Access Compliance Report

Public Rights-of-Way

(Curb Ramps)

Intersection ID: 10798	Main Street: W_5TH_ST	Cross Street: N_BRUNS_AV	Location: E
ADA ID: 947E39F5102A	Ramp Type: PerpDiag	Initial Pass/Fail: Fail	Overall Compliance: No
Severity Score: 25			
Codes/Mitigation Info/Possible Solution		Field Measurements/Component Compliance

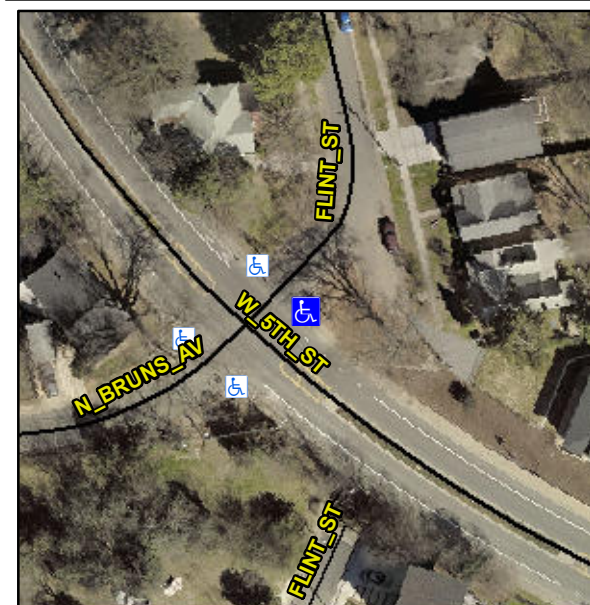
Not Found, R304.2.2, R304.5.3

Compliance	Description	Data	Compliance	Description	Data
N/A	Ramp Length (in)	74.0	No	Ramp Slope (%)	10.5
Yes	Ramp Width (in)	54.0	No	Ramp XSlope (%)	6.7
N/A	Flare Type LT	N/A	N/A	Flare Type RT	N/A
N/A	Flare Slope LT (%)	N/A	N/A	Flare Slope RT (%)	N/A
N/A	Flare Traversable LT?	N/A	N/A	Flare Traversable RT?	N/A
N/A	Landing Length (in)	N/A	N/A	DWS Provided?	N/A
N/A	Landing Width (in)	N/A	N/A	DWS Contrast?	N/A
N/A	Landing Slope (%)	N/A	N/A	DWS Length (in)	N/A
N/A	Landing X Slope (%)	N/A	N/A	DWS Full Width?	N/A
N/A	Landing Curb? (Y/N)	N/A	N/A	DWS Offset (in)	N/A
N/A	Shared Landing?	N/A			
N/A	Gutter Ponding?	N/A	N/A	Gutter Slope (%)	N/A
N/A	Gutter Lip Ht (in)	N/A	N/A	Gutter X Slope (%)	N/A
N/A	Painted X Walk1?	No	N/A	Painted X Walk2?	No
	X Walk 1 Direction	To NW		X Walk 2 Direction	To SW
N/A	X Walk 1 Width (in)	N/A	N/A	X Walk 2 Width (in)	N/A
	X Walk 1 Slope (%)	7.5		X Walk 2 Slope (%)	1.4
	X Walk 1 X Slope (%)	1.8		X Walk 2 X Slope (%)	6.0

Remove & Replace Curb Ramp With Two New Directional Ramps or Equivalent.
